Trust in water

Economic value of bioresources assets – feedback to companies

This document sets out feedback to the ten largest water and sewerage companies in England and Wales (companies) on their assessments of the value of their bioresources assets that each company submitted in September 2017.

Figure 3.1 Comparison of additional headroom of expected assets at 2020 compared to company proposed hypothetical assets using information on utilised capacity from 2016-17.

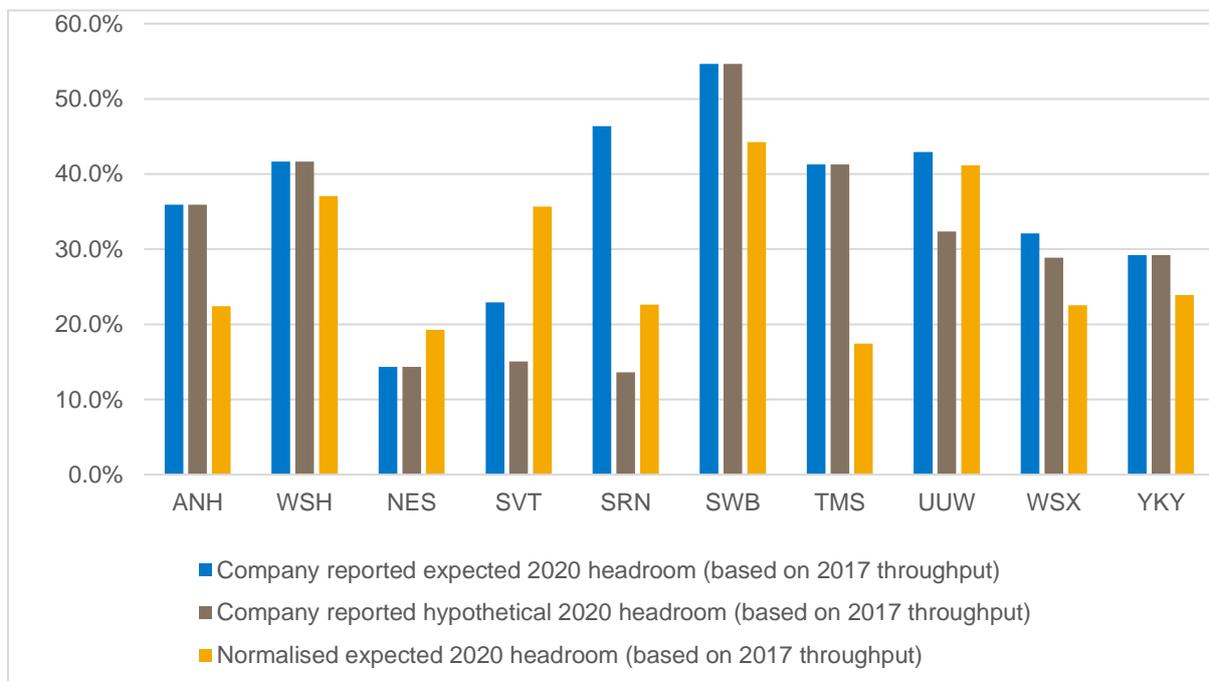
3.19 There is significant headroom across the industry. We accept some variation in headroom may reflect requirements of dispersed populations which may have remote assets and so less flexibility to economically transport bioresources to different sites. We consider the four companies that propose to value modern equivalent assets that have a lower capacity than the capacity of their actual assets are not clear outliers against the rest of the sector. This is either on each companies' assessment of actual headroom, or on our normalised basis.

3.20 Defining the modern equivalent with a lower capacity than actual assets implicitly carries the judgement that the excluded capacity has no economic

value. The four companies that have excluded capacity (Southern Water, Severn Trent Water, United Utilities and Wessex Water) have not provided compelling evidence that their capacity should be treated differently to other companies. We therefore consider that companies should value the capacity of all assets they anticipate may be used to provide bioresource services.

- 3.21 Our guidance set out that companies should consider the economic value of all their capacity at 2020. We expect that all companies will value modern equivalent assets with the same capacity as their expected actual assets at 2020. This excludes assets that are not expected to be used in any circumstance and therefore have no economic value.

Figure 4.1 Relative capital cost of modern equivalent assets per unit of normalised capacity

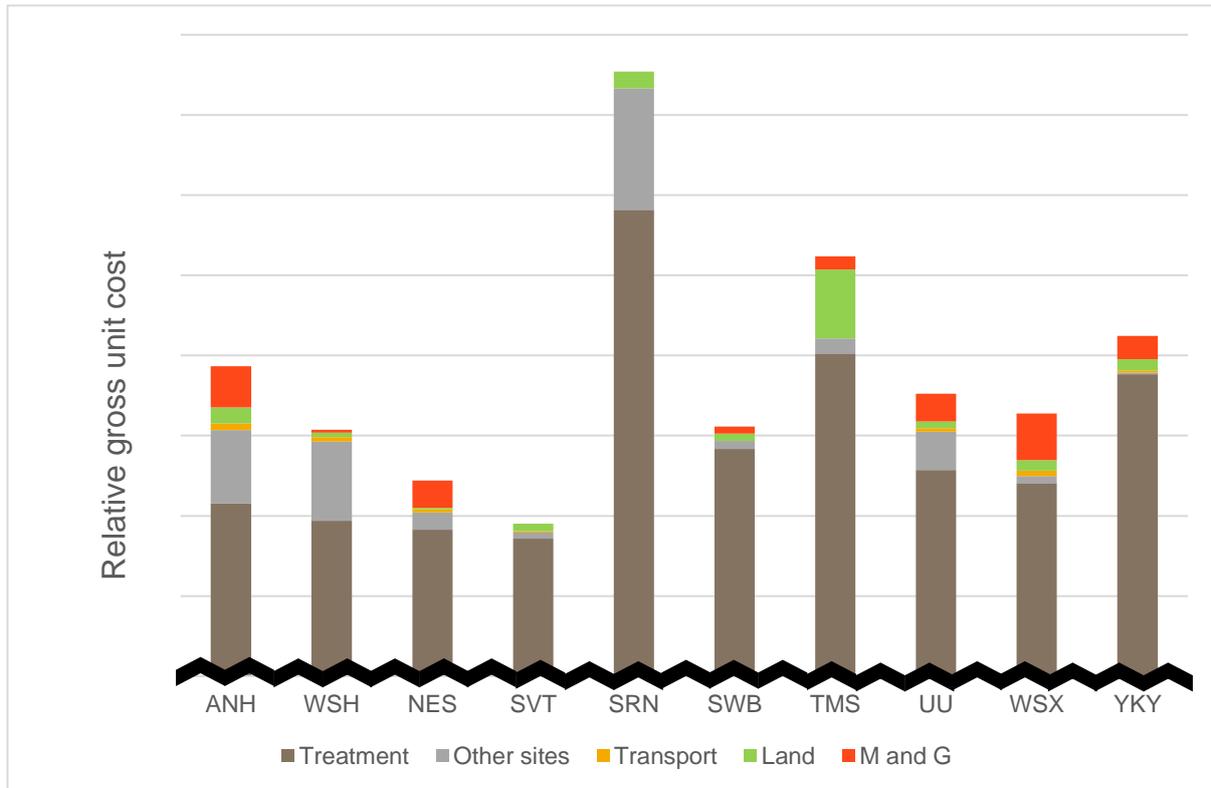
4.5 Figure 4.1 compares companies' modern equivalent costs per unit of normalised capacity.

- 4.15 All companies should consider the information we are publishing and test the assumptions they have made on gross costs.
- 4.16 We will consider further Anglian Water's view that shared assets, where the bioresources business unit is not the principal user, should not be included in the economic valuation. We expect all companies to identify a proportional allocation of the capital value of shared assets where the bioresource business unit is not the principal user. We will amend business plan table WWS12 to allow companies to report this information. We discuss amendments to WWS12 further in paragraph 5.73.

Figure 4.2 Comparison of average capital costs for three treatment technologies for different capacities of treatment centres.

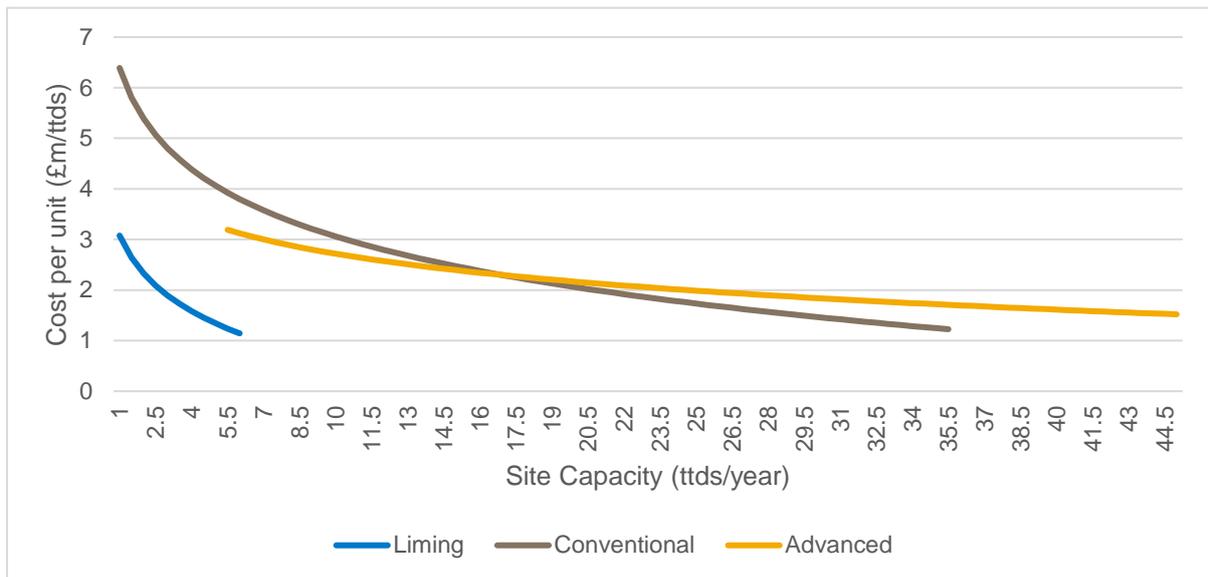
- 4.7 As expected, liming has the lowest capital costs. We expected that the capital costs for advanced digestion would be higher than conventional digestion, but this is not always the case. When outlier sites are removed the two curves converge. It may be that the extra costs of the pre-treatment for advanced digestion is offset by the reduced costs of not needing secondary digestion that is typically required for conventional digestion. The cost of land, is not taken into account in figure 4.2.

- 4.8 Overall, it appears that there is little difference between the capital costs of conventional and advanced digestion treatment technologies. We remain cautious of this result as it could be influenced by company and site specific factors. We note that, when considering whether to implement advanced technologies at a conventional digestion site, most companies' decisions will be influenced by sunk costs on site, such as secondary digestion assets.

Figure 4.3 Relative unit cost of gross capital costs of other sites per unit bioresources transported in 2016-17

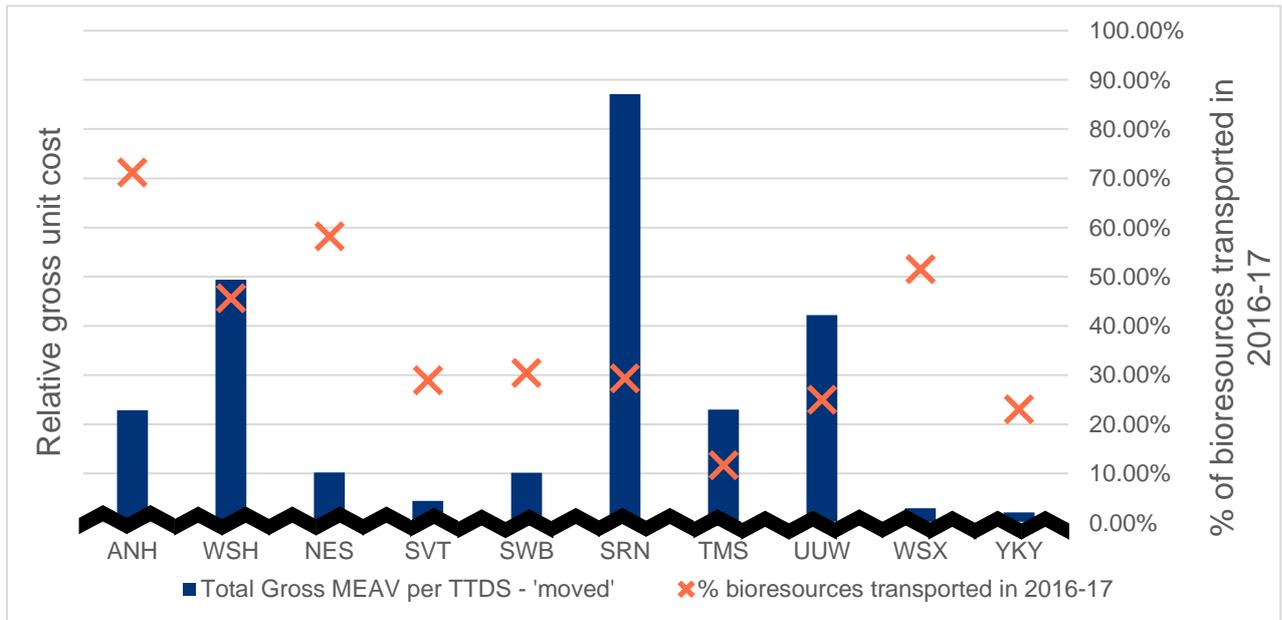
4.11 We have compared the capital costs of other sites per unit of bioresources transported, to reflect that intermediate sites are likely to be linked to the transportation of bioresources. We would expect the unit cost to be similar between companies. However, there are large differences between companies' unit capital costs. We note that not all other site costs will be intermediate thickening sites and not all of the bioresource that is moved is thickened at an intermediate site. However, it suggests that there is variation in the capital costs companies have assumed for intermediate thickening sites that is not explained by how rural companies are.

Figure 5.1 Comparison of adjustment for asset life compared to weighted average reported age of assets at 2020

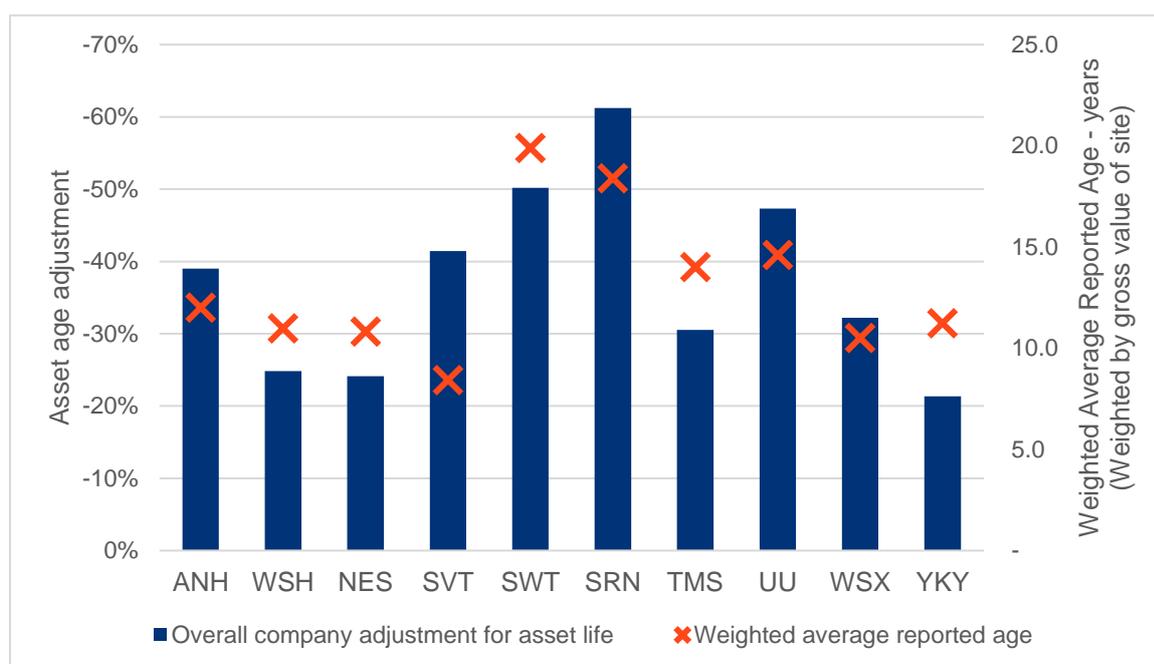
actual assets. As we have observed, we expect companies with older assets to have larger adjustments. This gives us some confidence in company adjustments.

5.14 While at a high level company adjustments appear reasonable, the approaches and assumptions companies have used in calculating these adjustments vary considerably.

Figure 5.2 Distribution of reported modern equivalent life by process (box and whiskers chart with added weighted mean life)

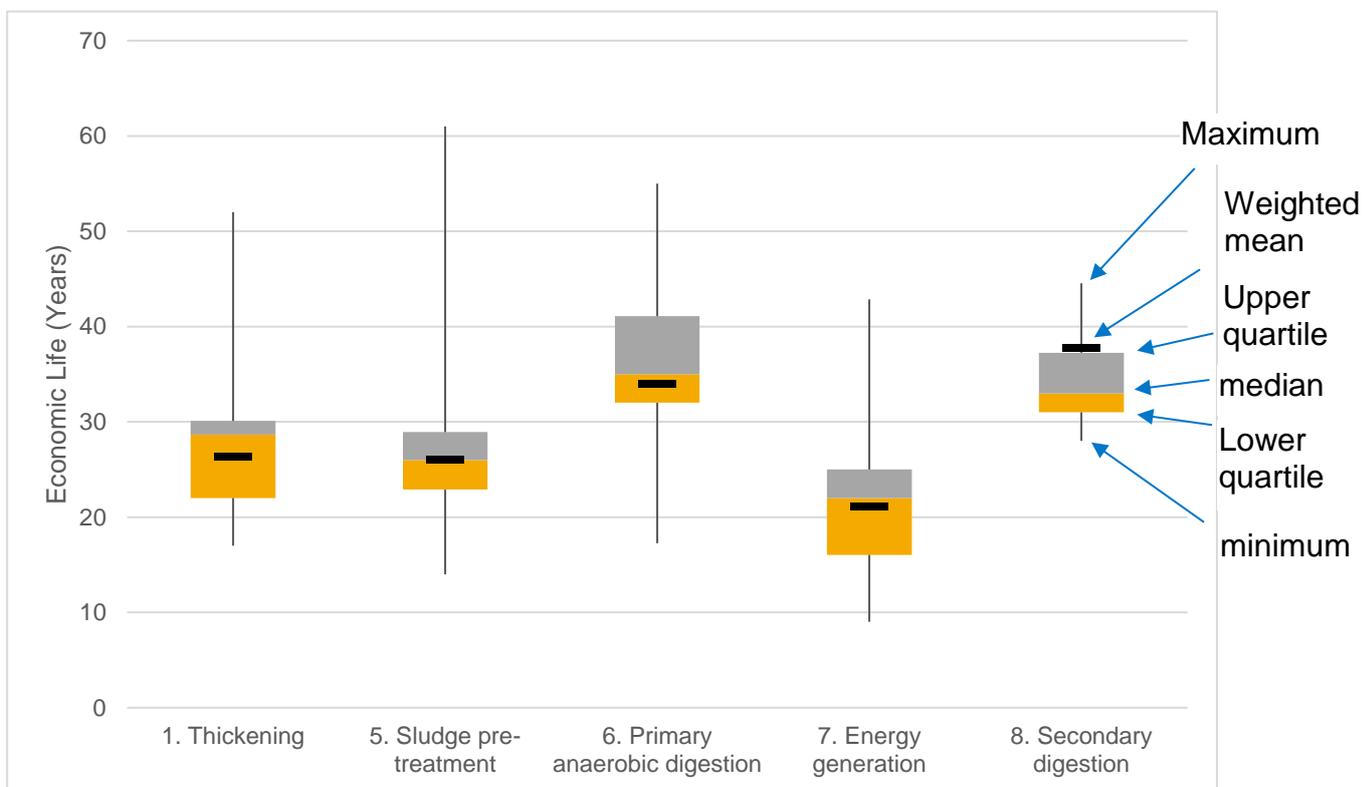
5.17 The variation between companies is significant and more than we expected for what we assume are similar assets built at the same time. Figure 5.2 shows the

5.19 We had expected that differences between the lengths of asset life would be due to the trade off with cost. For instance a company might be willing to incur a higher capital costs for a longer asset life or pay less for an asset that would not last as long. However, we could not find any relationship between cost and asset life.

- 5.26 Companies should reconsider if their reported modern equivalent asset lives are realistic in the context of their RCV valuation. In particular if site specific aspects are unduly affecting modern equivalent asset lives the company should consider relaxing these constraints. For consistency, if a company makes changes to its asset life it should also consider if it should change its assumptions on cost.

Figure 5.3 Average asset lives of modern equivalent and actual treatment centres

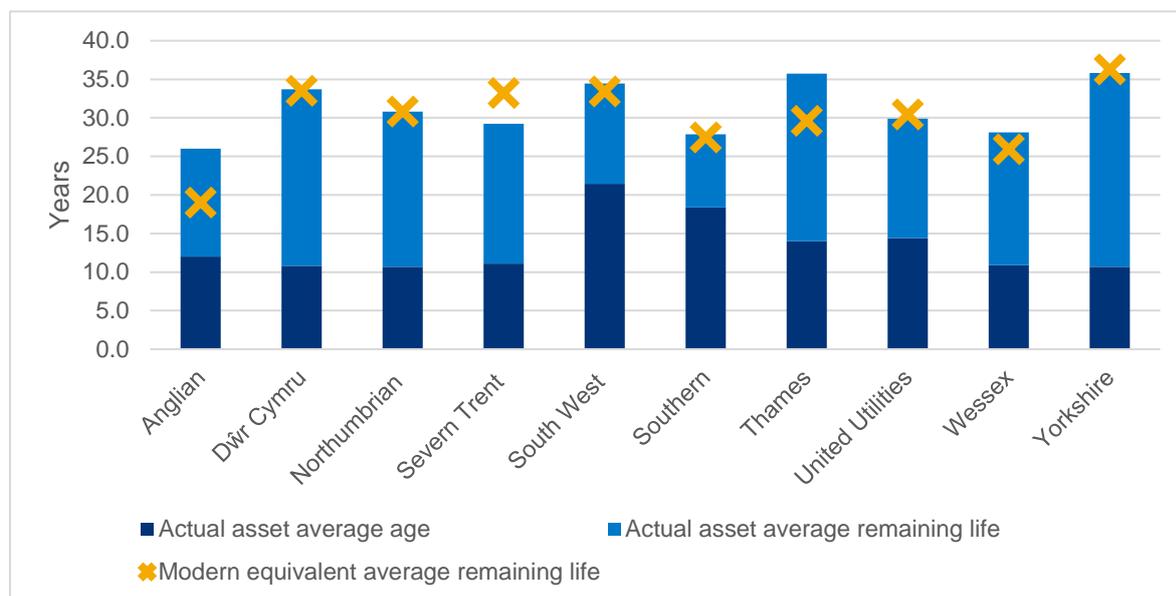
- 5.25 Figure 5.3 compares actual and modern equivalent average asset lives. We have weighted asset lives by the capital value of modern equivalent assets, as the adjustment for asset life is applied in proportion to the capital value.

Figure 5.5 Relative average income per unit of throughput for modern equivalent and actual STCs, including income from renewable energy incentives

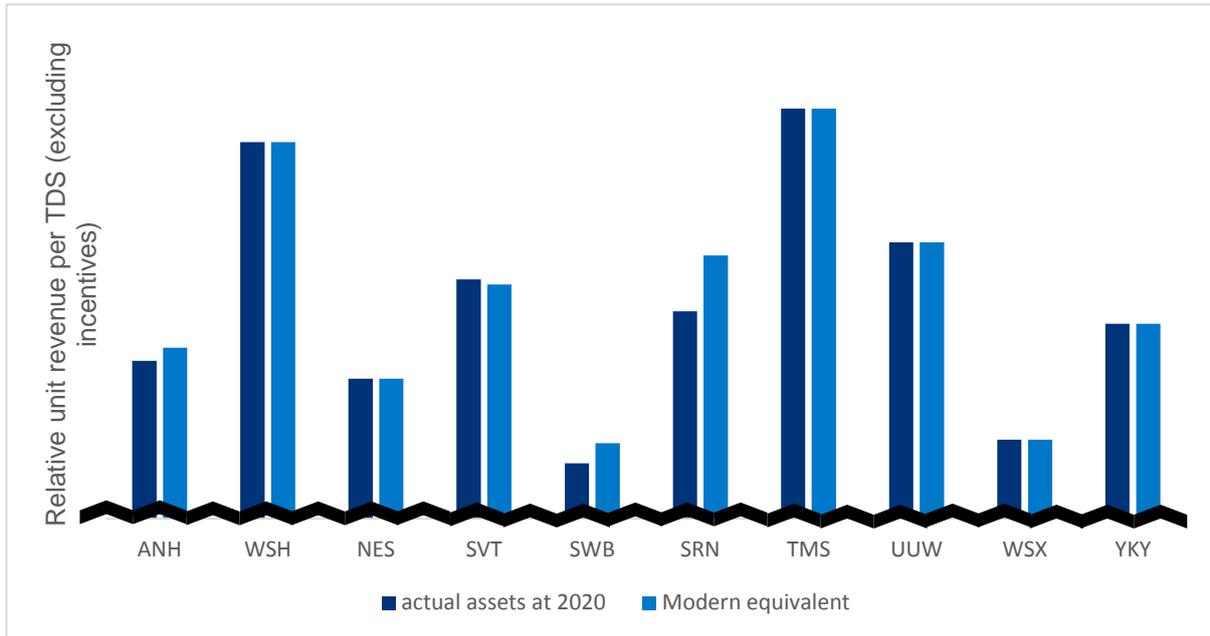
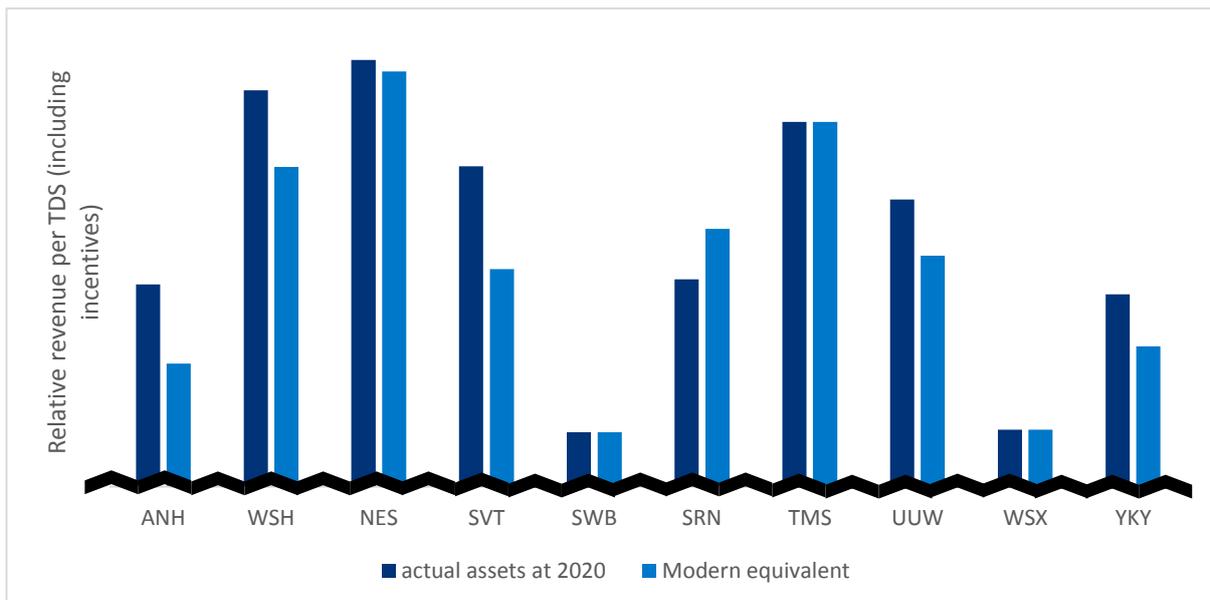
- 5.39 The impact of income from renewable incentives is marked and is likely to be a significant driver of economic value.
- 5.40 Companies have taken different approaches to their assumptions about future income from renewable incentives. Some companies assumed that there will be no income from incentives for new modern equivalent assets; some assumed ROCs reduce and RHI continues; some assumed ROCs and RHI continue at the same rate for 20 years; and some assumed there will be a new incentive regime for the hypothetical assets that will replace ROCs, giving an equivalent income to that enjoyed by the company’s current assets.

- 5.42 We expect companies to base the incentives available for existing assets and modern equivalent assets at 2020, according to what is set out at 30 April 2018. This includes what the government may indicate will apply at 2020 and companies should assume that the government will enact any commitments made by this date. Companies should consider the full range of incentives that may be available for modern equivalent assets.

Figure 5.6 Relative average annual cost per unit of bioresource throughput for modern equivalent and actual bioresources treatment centres

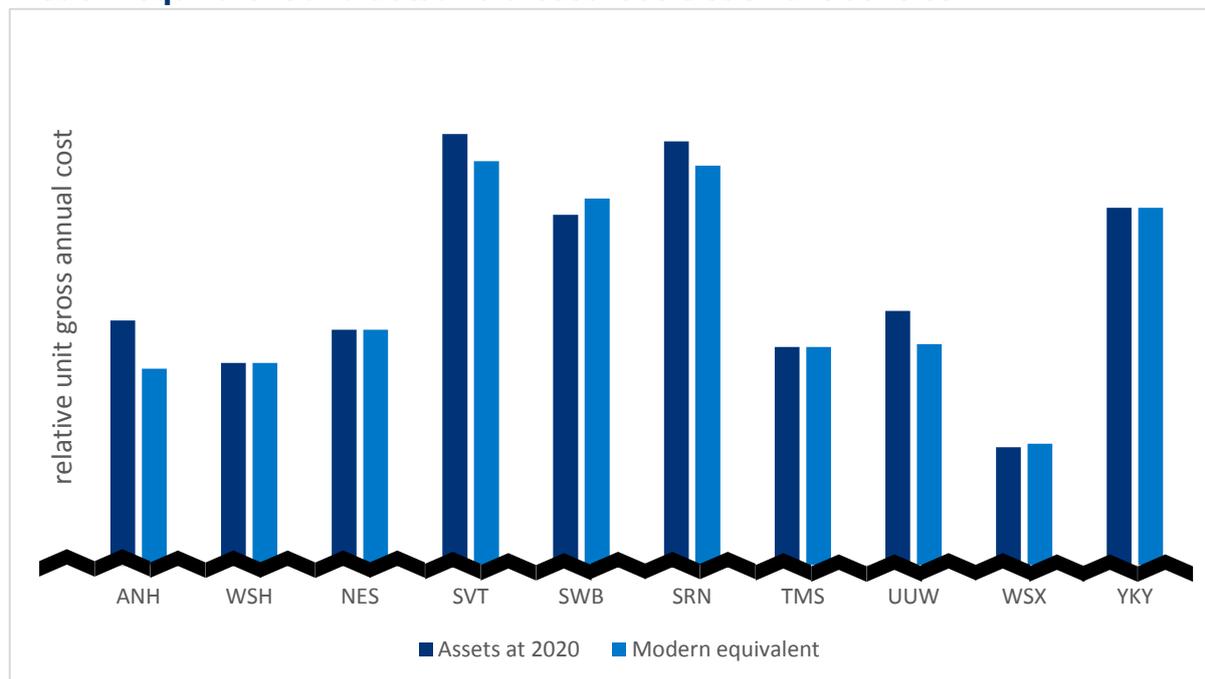
- 5.55 In general it was not clear to us if companies had considered whether there were likely to be differences in forecast capital maintenance costs between actual and modern equivalent assets over the remaining life of their assets. This may explain some of the variation in unit costs between companies.
- 5.56 Two companies, Anglian Water and United Utilities, noted that they expected modern equivalent assets would have lower costs of disposal than actual assets and had reflected this in their valuations.

Figure 6.1 Relative net unit annual cost (excluding renewable incentives) per unit of throughput and proportion of bioresources treated using advanced technologies.

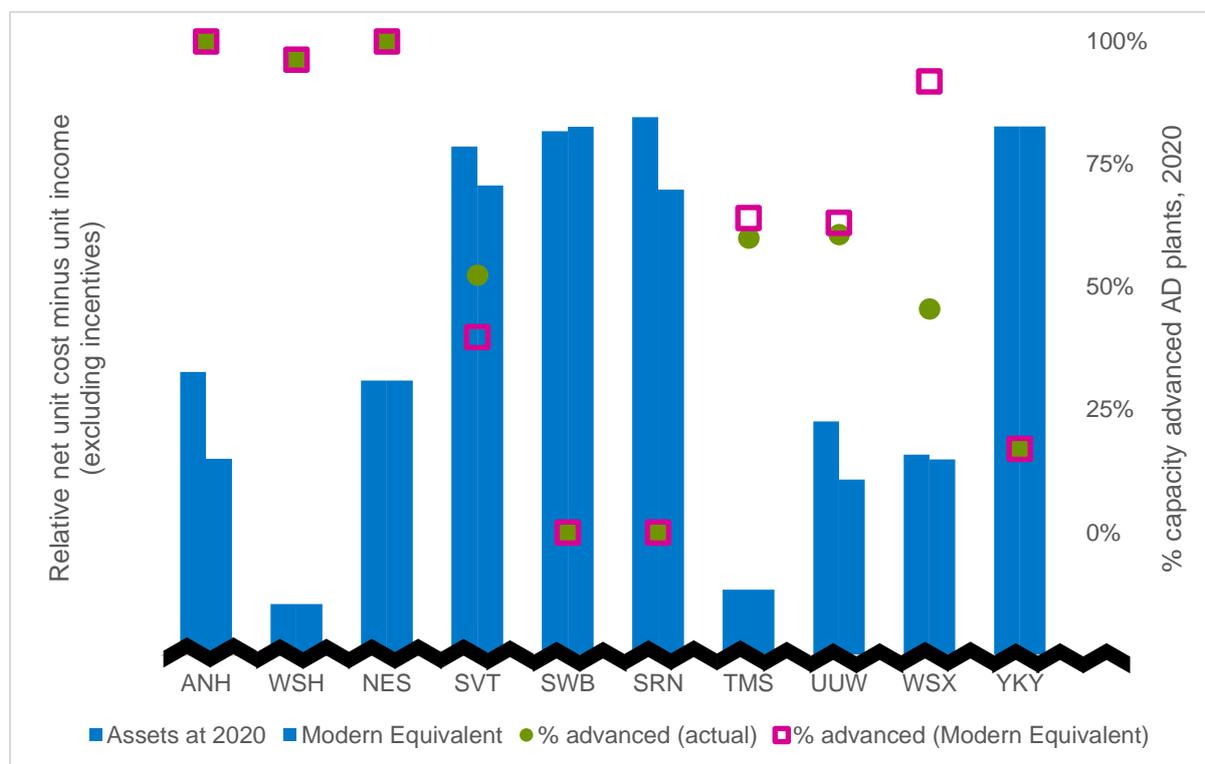
- 6.9 Figure 6.1 shows annual net unit cost by dividing annual net cost by the throughput. It also shows the proportion of bioresources capacity provided by advanced anaerobic digestion plants in 2020.

6.10 Figure 6.1 suggests that the higher the proportion of bioresources treated with advanced technologies, the lower its net unit cost of operation. It should be noted that this excludes the income from incentives. Advanced technology will tend to produce more biogas and so has a greater potential to receive income from renewable incentives.

- 6.8 Companies should consider whether a modern equivalent asset could receive renewable incentives. We expect it to do this on a site specific basis. What incentives could be available may depend on factors such as the proximity of the site to gas mains. If a company is able to receive renewable incentives it could further reduce its net costs.
